NOTICE TO BIDDERS

PROJECT NAME: Lesslie Elementary School, Chiller Replacement, Bid No. 22-23-14
PROJECT NUMBER: 22158 LOCATION: 250 Neely Store Rd, Rock Hill, SC
DESCRIPTION OF PROJECT: Replace existing packaged equipment on grade in area A and gym roof with new equipment in the same location.

ROCK HILL SCHOOL DISTRICT 3
LESSLIE ELEMENTARY SCHOOL HVAC
REPLACEMENT

1 PARTIAL FLOOR PLAN AREA A - GENERAL CONSTRUCTION PLAN
SCALE: 1/8" = 1'-0"

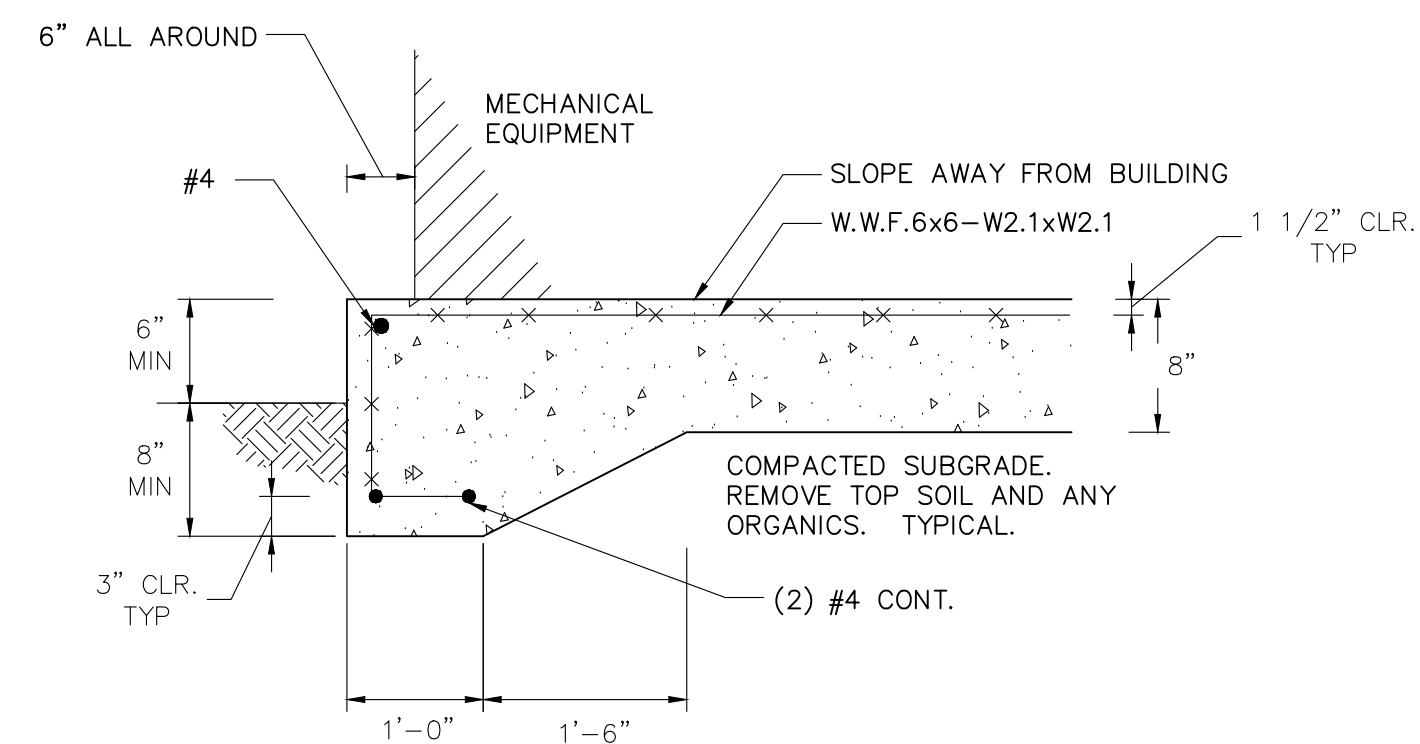
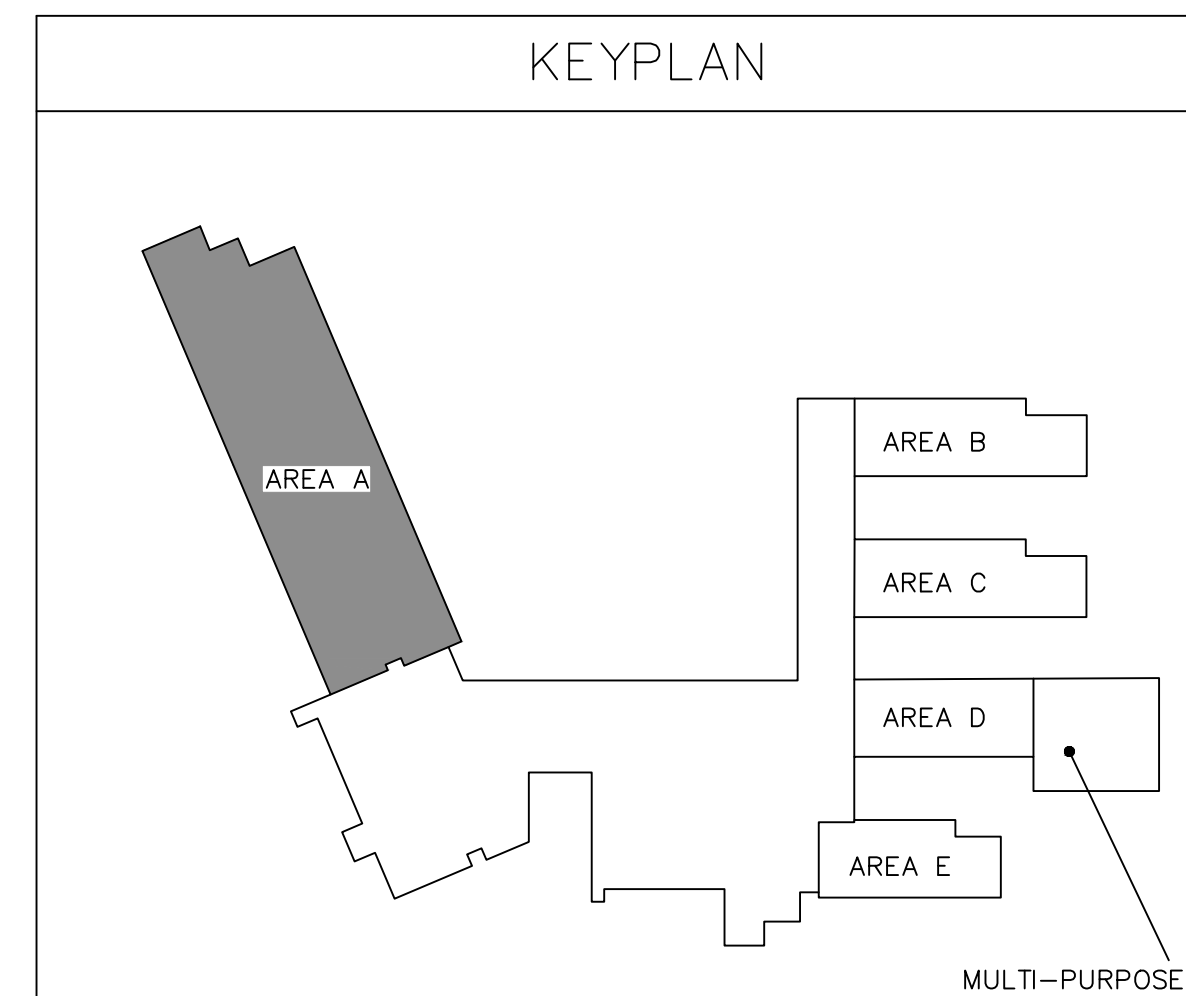
1. Units have been changed to 3-ton units without hot gas reheat. Units also require a LON communication card.
2. Bipolar ionization units to be located in each SPHP unit. See specifications.
3. Instead of raising the existing pad, the units should be provided with a 6" curb as indicated on the schedule.

1. CONTRACTOR TO EXTEND EXISTING CONCRETE PAD AS INDICATED. CONTRACTOR TO VERIFY EXISTING CONDITIONS AND DIMENSIONS PRIOR TO POURING.

1
PARTIAL FLOOR PLAN AREA A - HVAC RENOVATION
SCALE: 1/8" = 1'-0"

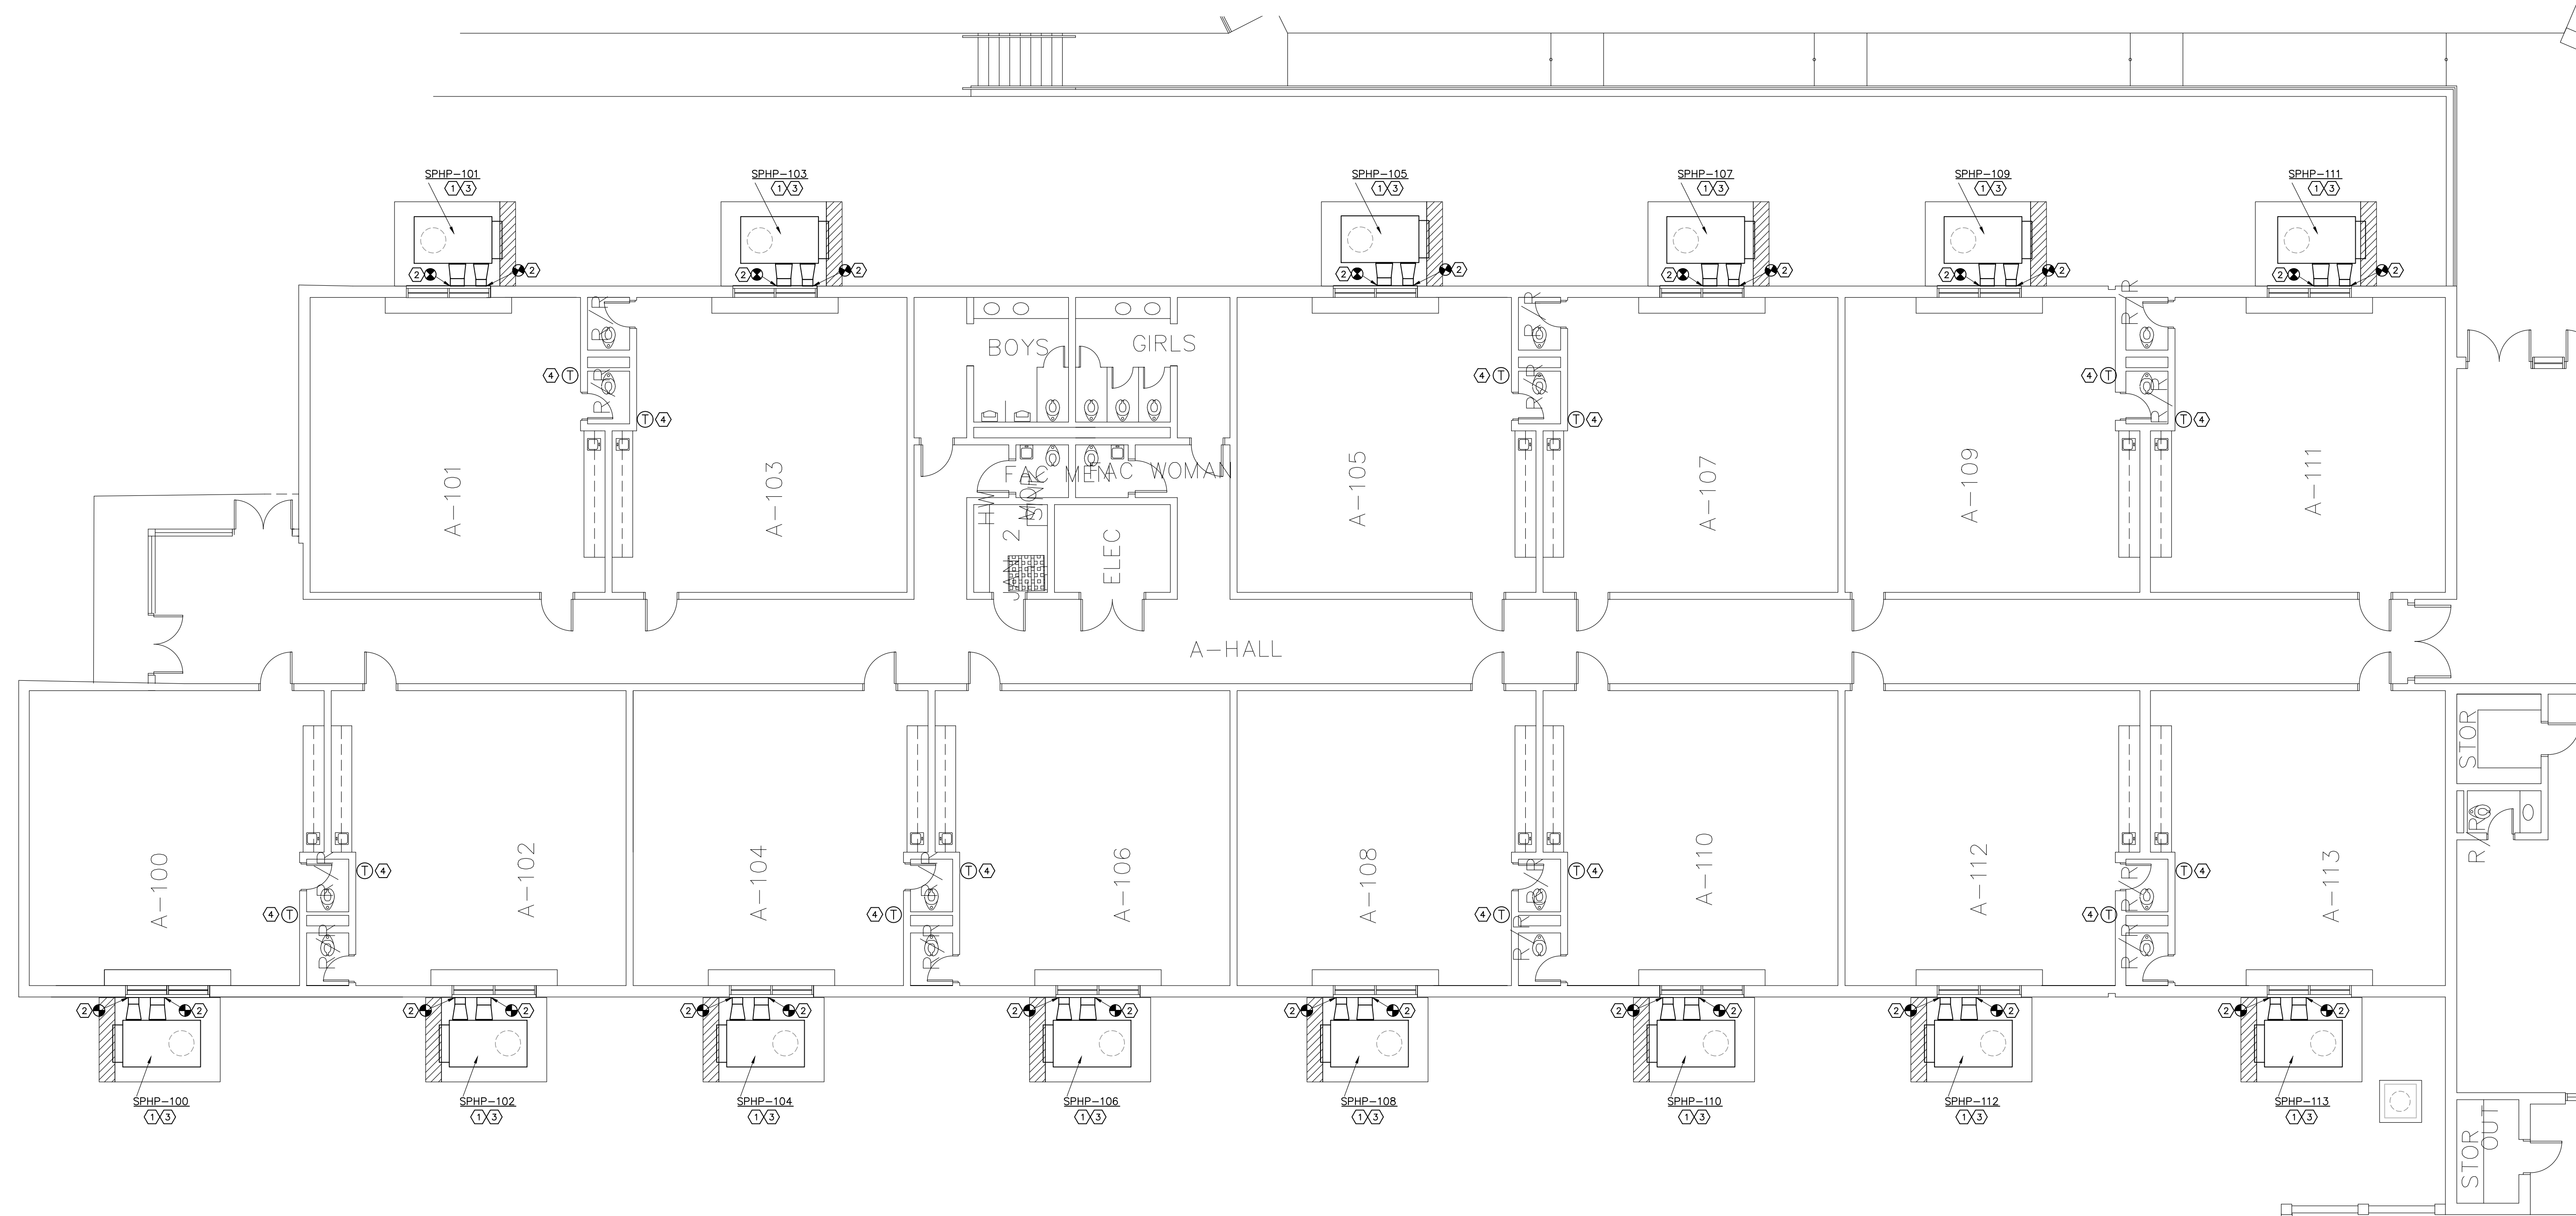
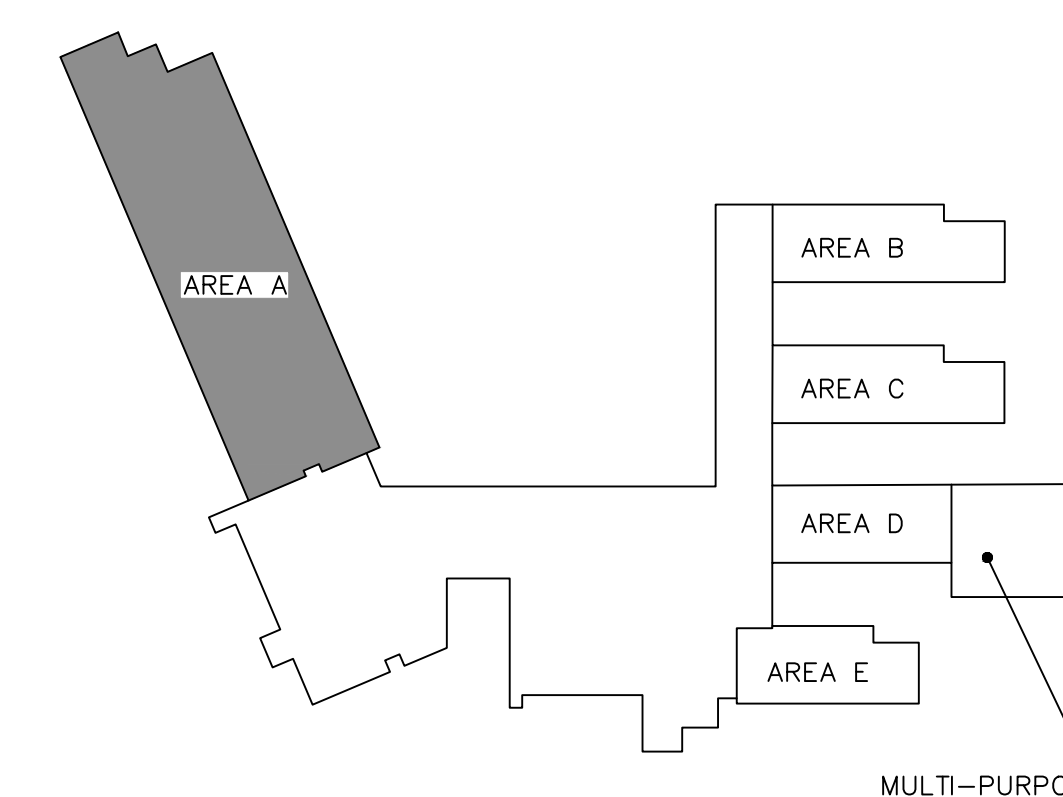
1. INSTALL NEW SPHP ON NEW 6" EQUIPMENT CURB.
2. DUAL WALL SUPPLY AND RETURN DUCTWORK ON THE EXTERIOR. CONNECT DUCTWORK TO EXISTING DUCTWORK
3. ROUTE CONDENSATE DRAIN LINE TO DRYWELL. SEE DETAIL.
4. PROVIDE NEW T-STAT IN SAME LOCATION AS EXISTING. FIELD VERIFY EXACT LOCATION.
